# TECHNICAL BULLETIN

## BELL-LARS HANDLING SYSTEM

SECURITY AND FUNCTIONAL EQUIPMENT IMPROVEMENT FOR THE BELL HANDLING SYSTEM.

FD40 - 00xx

BELL -LARS- HANDLING SYSTEM

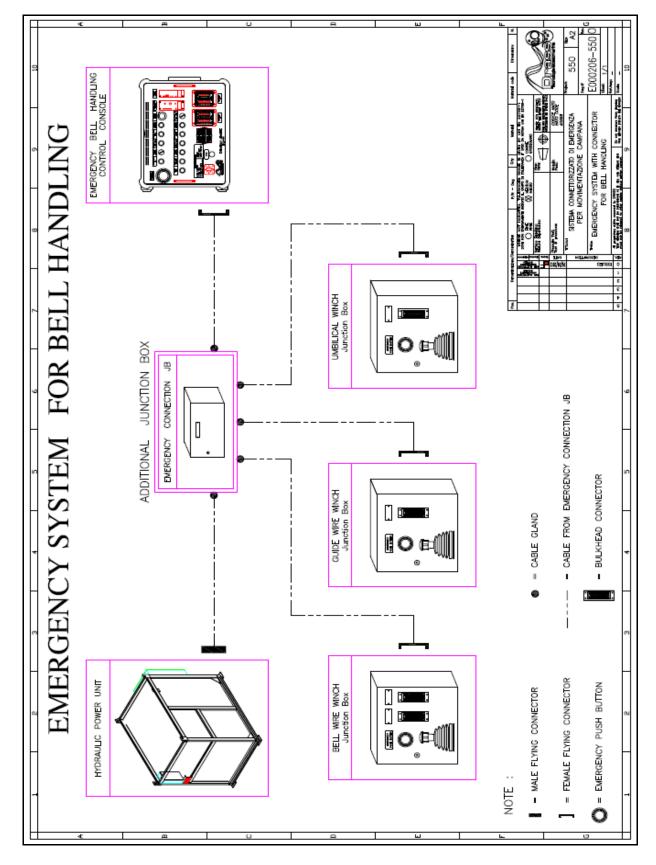
THIS NEW MODIFICATION ALLOWS THE LARS OPERATOR TO MANAGE THE SYSTEM USING THE EMERGENCY HANDLING CONSOLE WITHOUT THE NEED FOR CONNECTION WITH THE BELL HANDLING CONTROL CONSOLE AND THE SWAPPING UNIT; THE PORTABLE CONSOLE IS DIRECTLY CONNECTED TO THE HYDRAULIC POWER UNIT (HPU).

THE UPGRADE KIT ALSO OFFERS THE POSSIBILITY TO INCREASE THE SAFETY LEVEL THROUGH A BETTER CONFIGURATION OF THE EMERGENCY PUSH-BUTTONS AND DUMMY FLYING CONNECTORS.

USING A DEDICATED EMERGENCY LOOP, THE EMERGENCY PUSH BUTTONS DIRECTLY CONTROL THE HPU POWER SUPPLY, STOPPING THE SYSTEM UNTIL A SAFE SITUATION IS RESTORED.

- AN ADDITIONAL JUNCTION BOX, CALLED "EMERGENCY CONNECTION JB" FROM WHICH CABLES WITH FLYING CONNECTORS ARE ROUTED. THESE CONNECT THE JUNCTION BOX TO THE OTHERS BOXES OF THE HPU, BELL WINCH, GUIDE WIRE WINCH, UMBILICAL WINCH AND EMERGENCY B.H.C.C. (SEE DRAWING PAGE 3). THE LENGTH OF THESE CABLES SHALL BE CHOSEN ACCORDING TO THE VESSEL DESIGN IN ORDER TO ALLOW THE MAXIMUM POSSIBLE VISIBILITY IN THE HANGAR AREA.
- BULKHEAD CONNECTORS TO BE INSERTED IN THE JUNCTION BOXES OF THE HPU, BELL WINCH, GUIDE WIRE WINCH, UMBILICAL WINCH (IF NOT ALREADY PRESENT).
- New dummy connectors to be inserted between flying connectors "A" and "B" situated inside the Bell Handling Control Console.
